Revised Site Investigation Workplan

Former Texaco Service Station (Chevron Site # 307233) 2259 First Street

Livermore, CA

Subject: Fuel Leak Case No. RO0002908 and Geotracker Global ID T0600196622, Miller Square Park, 2259 First Street, Livermore, CA 94550

Recommended Sampling Locations

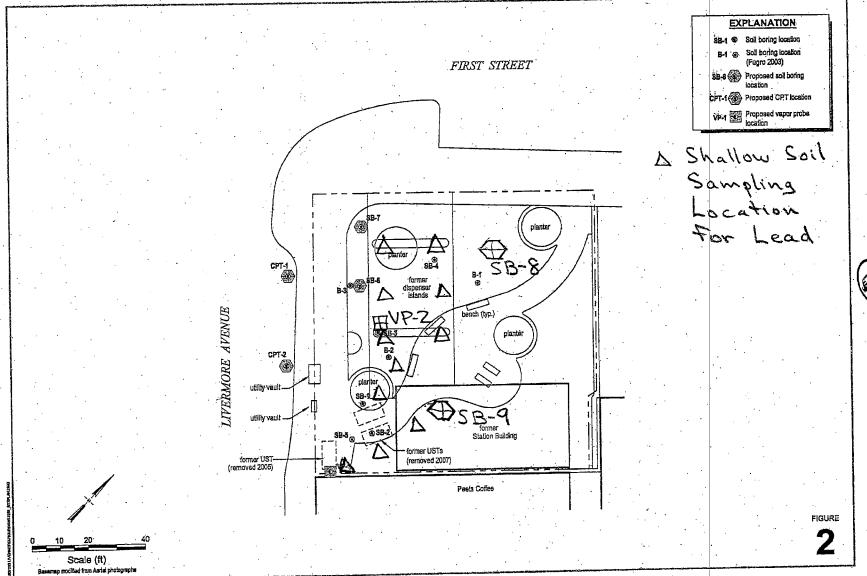
- 4. Soil Vapor Sampling. The proposed method for installation of a nested probe and collection of soil vapor samples is acceptable. We request that one additional soil vapor probe be installed in the area of the former dispenser islands to evaluate whether elevated concentrations of fuel hydrocarbons in soil have resulted in elevated concentrations of benzene in soil vapor. In the Revised Work Plan requested below, please include the additional soil vapor sampling location shown on the attached figure entitled, "Recommended Sampling Locations."

- Direct Push Borings. The proposed boring locations for direct push borings SB-6 and SB-7 are acceptable. However, we request that two additional direct push borings be advanced at the locations shown on the attached figure entitled, "Recommended Sampling Locations." The soil borings are to be advanced approximately 10 feet below first encountered groundwater in order to collect a grab groundwater sample from each boring; however, we request that the depth of the boring be extended if contamination is observed at the total depth of the boring. The soil borings are to be visually logged continuously in the field for soil type, color, moisture content, odor, and other observed features and screened with a photoionization detector. Soil samples are to be collected for laboratory analysis at any interval where visible staining, odor, or elevated PID readings are observed. If visible staining, odor, or elevated PID readings are observed, a sufficient number of soil samples must be collected to characterize the vertical interval over which the contamination occurs. If no visible soil staining, odor, or elevated PID readings are observed in the soil boring, we request that soil samples be collected for laboratory analyses at a maximum of 10- foot intervals from 5 feet bgs to the total depth of the boring. Please present plans for the direct push borings in the Revised Work Plan requested below.

CPT Borings: CRA proposes to advance two CPT borings (CPT-1 and CPT-2) to approximately 80 fbg (Figure 2). CRA will attempt to collect grab groundwater samples from zones identified by lithology as being potentially water bearing. Soil samples will be collected at the capillary fringe zone, if encountered, and at intervals of distinct lithologic change where potential hydrocarbons could become perched. Upon completion, the borings will be filled with Portland type I/II grout using a tremie pipe and patched to match the existing surface. CRA's Standard Field Procedures for Cone Penetrometer Testing and Sampling is presented as Attachment B.

GeoProbe® Borings: CRA will advance four GeoProbe® borings within Mills Square Park to approximately 10 feet below the first occurrence of groundwater, if encountered (Figure 2). Boring depth will be extended if contamination is observed at the total proposed depth of the boring. Grab groundwater samples will be collected from each boring, if groundwater is encountered. The soil borings will be logged continuously in the field using the Universal Soil Classification System (USCS) ASTM D-2487 guidelines and will be screened with a photo-

Vapor Probes: CRA will install nested vapor probes at 5 fbg and 10 fbg in a boring adjacent to the building on the southeastern property line (Figure 2). It is estimated that the total depth of the boring will not exceed 11 fbg. Soil samples will be collected using a hand-auger above 8 fbg and using a split-spoon sampler at depths greater than 8 fbg. Although ACEHS has asked for an additional vapor probe within the park, a probe at that position will not provide additional information regarding human health risk due to vapor intrusion into any of the nearby buildings. Therefore, if the site is redeveloped in the future for either residences or commercial buildings, a complete vapor survey will be performed to determine if vapor intrusion would be a concern.
